DEPARTMENT OF PLANNING
STAFF REPORT

PLANNING COMMISSION PUBLIC HEARING

DATE OF HEARING: March 23, 2011

CMPT-2010-0008; New Road Substation

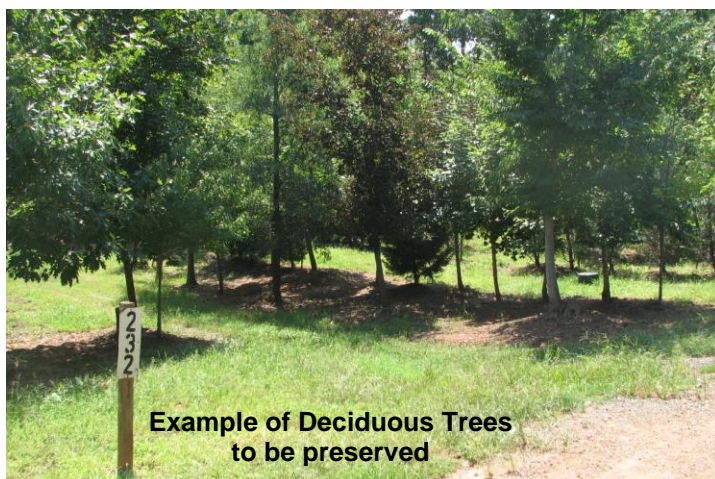
Of the 21.85 acres, 8.8 acres are located within the 300' no-build buffer along Bull Run. The proposed substation encroaches into approximately 1.5 acres of the 300' no-build buffer and approximately 1.7 acres of the 200' transitional buffer but is outside of the major floodplain and 50-foot management buffer. The Plan allows selective development within the river and stream corridor resource areas that will support or enhance the biological integrity and health of the river and stream corridor. The Plan permits the location of utilities within the no-build buffer and transitional buffer but requires that the encroachment into these areas utilize River and Stream Corridor Resource performance standards and best management practices to reduce or eliminate adverse impacts to aquatic life, riparian forest, wetlands, and historic and archaeological sites.

Staff's preference would be to shift the substation further north and east so that the limits of disturbance are entirely outside of the 300' no-build buffer and a majority of the limits outside of the 200' transitional buffer. Due to the configuration of the parcel, the removal of the substation completely outside of the 200' transitional buffer may not be possible. However, a shift in the location would position the substation closer to the residential dwellings to the north and east and result in running longer overhead connections to the power lines, resulting in additional visual impacts. The shifting of the site would also require the elimination of tree species previously planted in conjunction with the nursery and landscaping business that are proposed by the Applicant to be preserved. The Applicant recognizes that the substation encroaches into the no-build buffer and transitional buffer but has expressed their desires to retain the location of the substation as close as possible to the existing overhead lines. Any significant shifts in the substation location would require Dominion Power to reapply to the SCC. The Applicant is sensitive to environmental impacts to the Bull Run tributary and has agreed to provide certain measures to balance the encroachment into these areas.

The Applicant conducted a tree inventory to identify trees most appropriate for conservation along the eastern and northern portions of the property adjacent to North Fork Bull Run and areas south of the utility substation within the 300' no-build buffer. The completion of the tree inventory identified 159 deciduous and evergreen trees that are appropriate for preservation. The deciduous tree trunk diameters generally range in size between 2.5

northern portions of the property adjacent to North Fork Bull Run in addition to preserving the existing forest cover along the banks of Bull Run and North Fork Bull Run. The Commission Permit plat illustrates the preservation of the 159 trees within "Tree Maintenance Areas" while the preserved forest cover along the North Fork Bull Run and Bull Run are identified as "Tree Preservation Areas." Approximately 7.32 acres of the 8.8 acres located within the 300' no-build buffer will remain undisturbed and will serve as a vegetated open space buffer adjoining the tributaries.

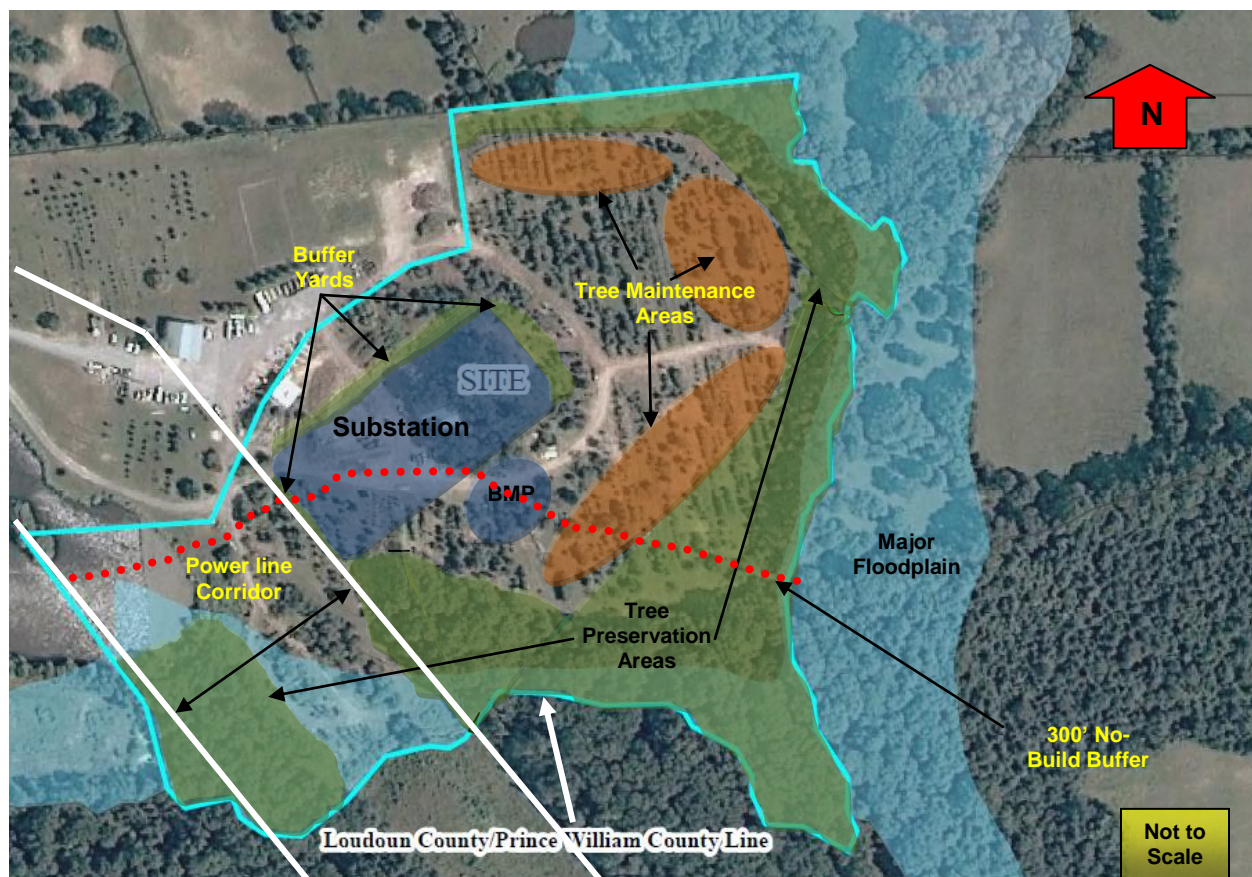
During the review of the application, staff identified several plat corrections. The applicant has revised the plat according to staff comments. One of the more significant comments dealt with portions of the substation encroaching into the 150' Scenic Creek Valley Buffer and the requirement to modify the buffer area prior to Site Plan approval. After further review of the substation location, the Applicant has shifted the substation slightly to the north and east to avoid encroaching into the Scenic Creek Valley Buffer, therefore preserving the buffer area while negating the need to request a modification at the time of Site Plan. The shifting of the substation also eliminated the encroachment into areas of steep slopes. Also as part of Zoning's review, it was noted that the Type IV buffer yard along the western limits of the substation could not be located within the existing 50' VEPCO easement. The plan has been revised to use existing vegetative

areas along the western property boundary to serve as meeting the Type IV Buffer requirement. Per Section 5-1403(B) of the Revised 1993 Zoning Ordinance, at time of Site Plan, the applicant must demonstrate that the vegetation, when supplemented by new vegetation, meets the Type IV buffer yard requirement. Zoning Staff does not have any outstanding comments.
